# City of Norcross

### **Architectural Review Board**

Petition Number: COA2025-027

Project Type: Demo/Consideration of a New House  
 Property Location: 146 Barton Street  
 Tax Parcel ID: 6254 135  
 Petitioner: Susan Tanner  
 Petitioner's Request: Demolition of a Historic Structure and Consideration of a New House

1 2nd Floor Plan  
 ABS / SCALE: 1/4" = 1'-0"

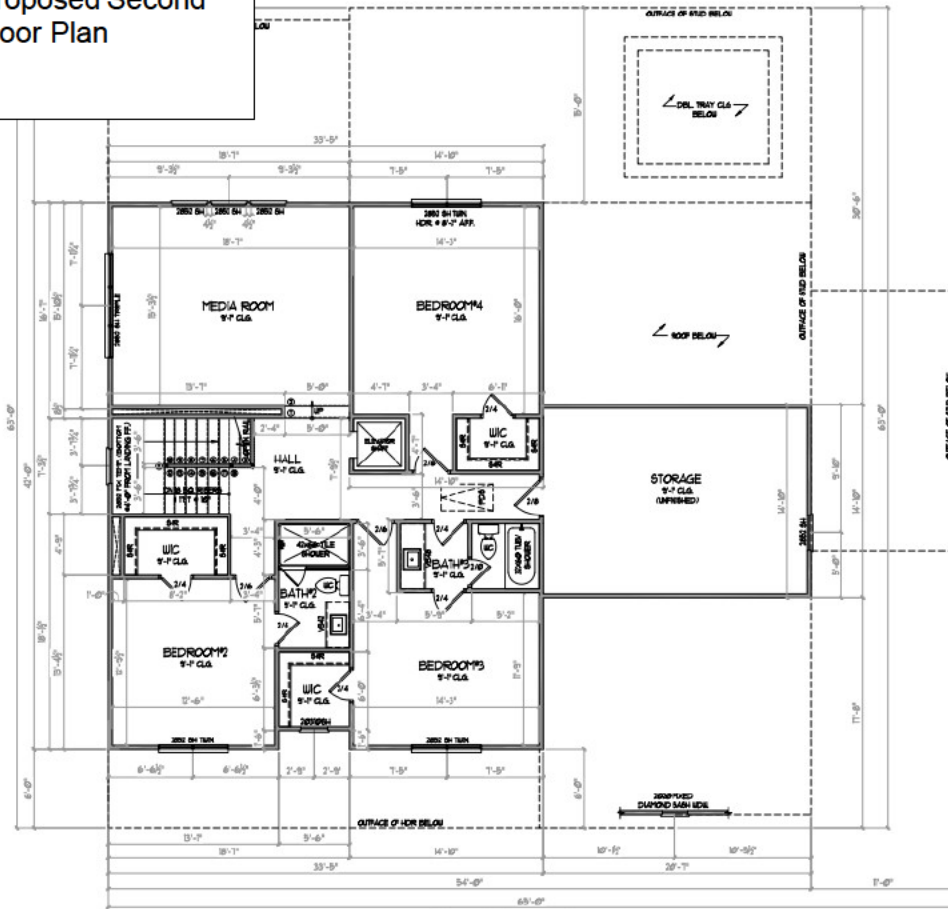
**Discussion Item:** Provide material being used for garage door. Does this elevation match the proposed floor plan as it pertains to the garages? The two-car garage on the floor plan appears to be on the front, while the front elevation appears to show a one car garage.

Proposed Rear Elevation

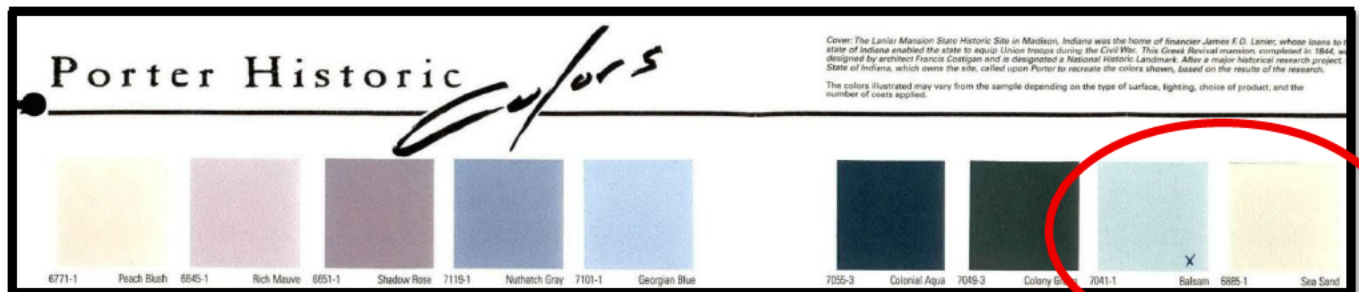
**Discussion Item:** Why 10" columns along the rear, and 8" columns along the front? Perhaps the sizes should be switched or the same.
